CJ Industries Limited's resource consent applications at 134 Peach Island Road, Motueka for gravel extraction with vehicle access via a right of way over 493 Motueka River West Bank Road, Crown land and unformed legal road - Council reference RM200488 and ors

REPORT UNDER SECTION 42A OF THE RESOURCE MANAGEMENT ACT 1991

Resource application by	CJ Industries Limited
Application number	RM200488 and RM200489
Site address	134 Peach Island Road, Motueka
Legal description	Lot 2 DP 2357 (RT NL77/73) and Lot 2 DP 432236 (RT 524970)
Report and recommendation prepared by:	Susanne Bernsdorf Solly, Senior Consultant Planner

Figure 1: Ownership of land adjacent to the haul road

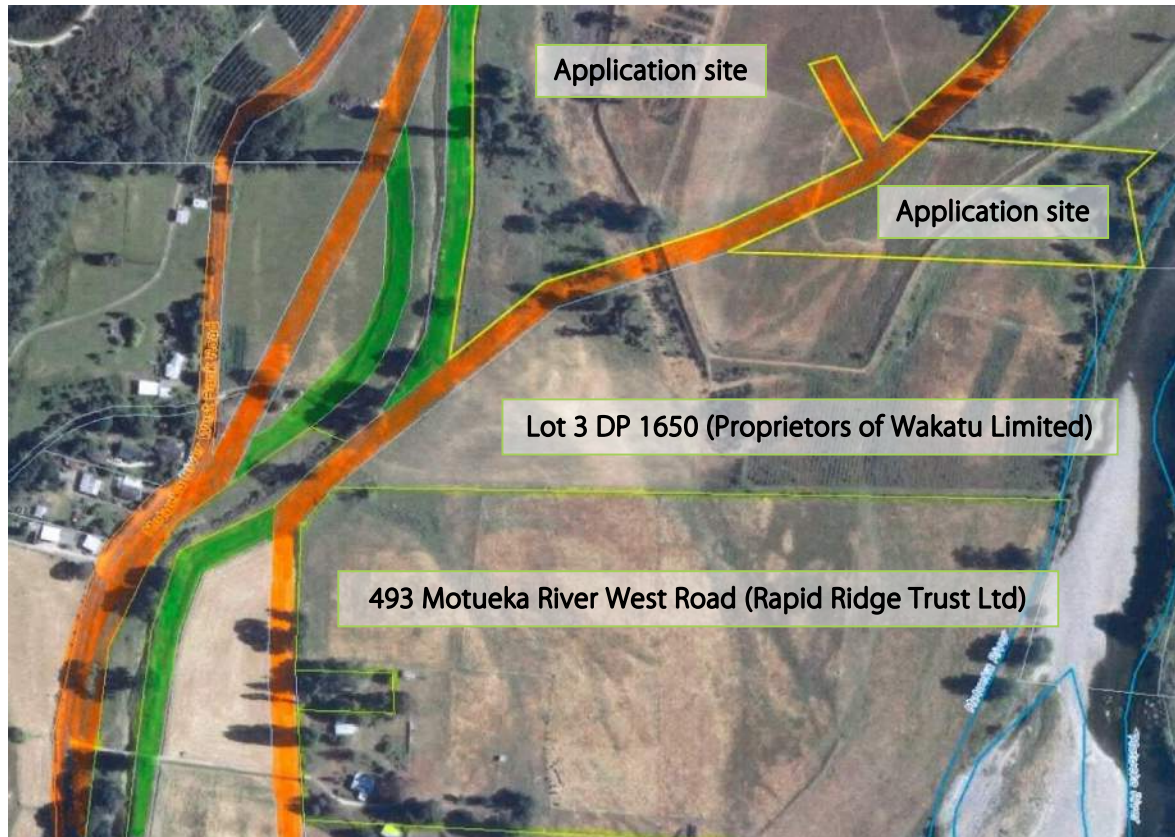
- 9.3 The applicant proposes to utilise the existing vehicle crossing to 493 Motueka River West Bank Road as detailed in Section 2.3 and Figure 2. As shown in Figure 1: Ownership of land adjacent to the haul road, the access from the legal road corridor initially crosses a strip of land (Section 1 Survey Office Plan 15112) which forms part of 493 Motueka River West Bank Road and contains an existing bridge crossing the overflow channel. The proposed access then turns north and follow a strip of crown land before intersecting the "paper road".

Figure 10: Location of dwelling on 131 Peach Island Road (source: Google maps)

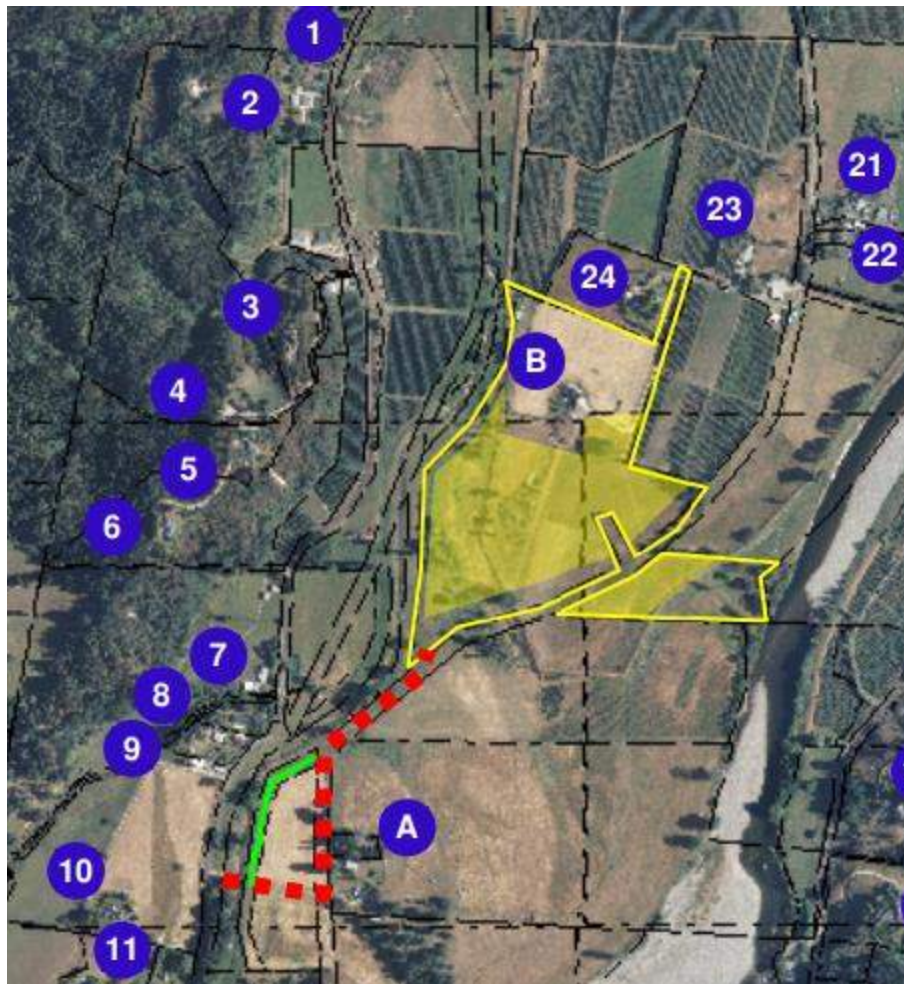
- 8.7 With regards to the noise report, J & V Walker (submission 16) 130 Peach Island Road, and GH & CM Le Frantz (submission 37) 131 Peach Island Road, note that the dwelling at 131 Peach Island Road, owned by Le Frantz, has been omitted from the report. The dwelling and associated groundwater bore was recently constructed (building consent was granted in late 2019) and is not yet shown on the Top of the South Maps aerial. Figure 10 shows the location of the dwelling, which is situated

- 8.32 Whilst I consider that good site management practices and a robust dust, sediment and erosion control plan can adequately control the effects of dust on the wider environment, I am concerned with the close proximity of the proposed extraction to very dust sensitive receptors (orchards, dwellings), in particular the proximity of Stage 2 to 131 Peach Island Road (refer to Figure 10). I invite the applicant to consider additional measures to address this.

Figure 12: Proposed planting (red lines) overlaid on 10-year ARI event.

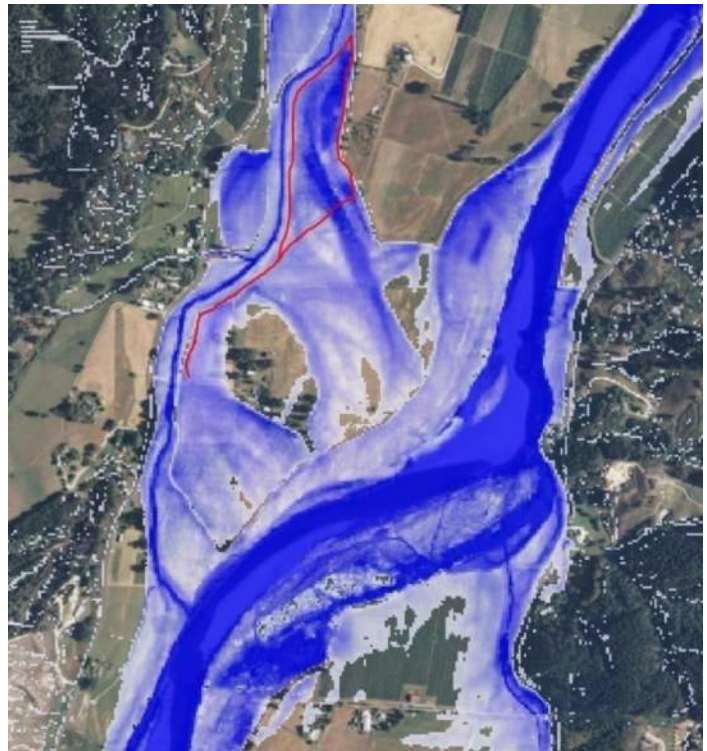
- 11.11 The Landscape Mitigation Plan includes shelterbelt type planting to go right across the overflow channel that accepts flood flows. While there are already high levels of woody vegetation in this overflow channel in places, Mr Griffith notes that the proposed planting *“would be right across and close to the head of this channel.”*

- 11.12 The red line in Figure 12 below shows the proposed planting lines overlaid on a Q₁₀ event (i.e., a 10-year ARI event). The flood flow direction is from south (bottom) to north (top).

11.13 Mr Griffith is not concerned with the planting lines running parallel with river flow (as long as a 5m setback from the stopbank is maintained) but would prefer no plantings (or fencing) to cross the channel. Mr Griffith notes that flexible 'laydown' plantings such as toe toe, carex species or scattered single trunked trees (no more than one per 10m) would be acceptable, however, this may not achieve the desired visual screening the applicant is seeking.
